In the Matter of)
HOUSTON LIGHTING & POWER COMPANY) Docket No. 50-466
(Allens Creek Nuclear Generating)
Station, Unit 1))

NRC STAFF'S RESPONSES TO JOHN F. DOHERTY'S
JULY 17, 1979 SET OF INTERROGATORIES

SECTION A-A

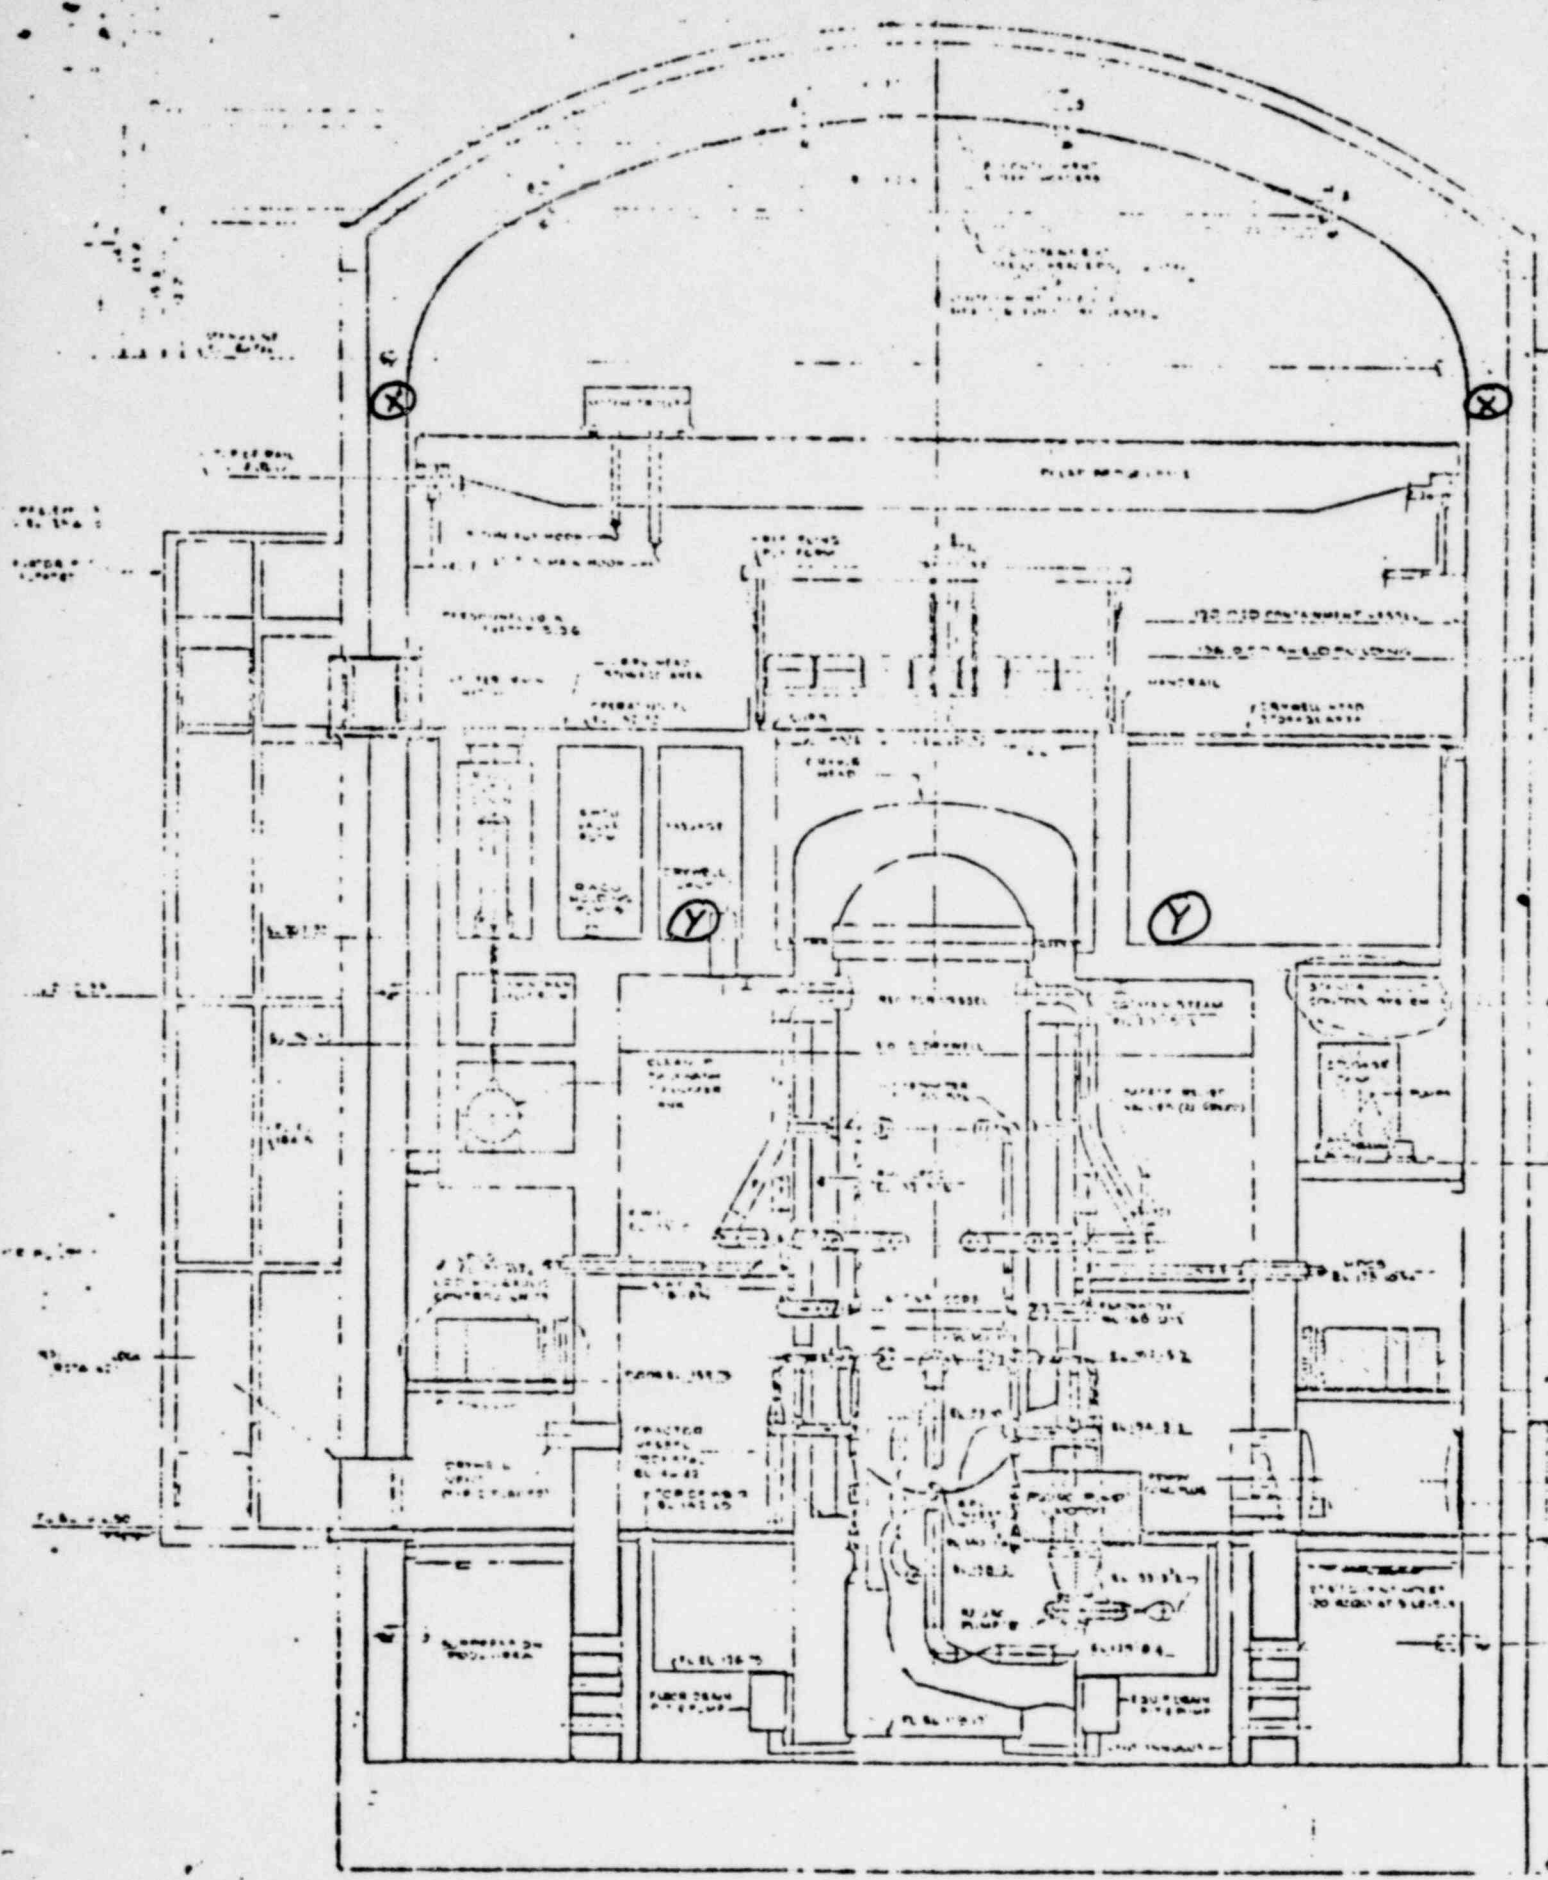
6. On the enclosed drawing, indicate where some (but not necessarily all) containment vacuum breakers are located with an "X", please.

7. On the same drawing indicate where some drywell containment breakers are located with a "Y", please.

See attached drawing.

See attached drawing.
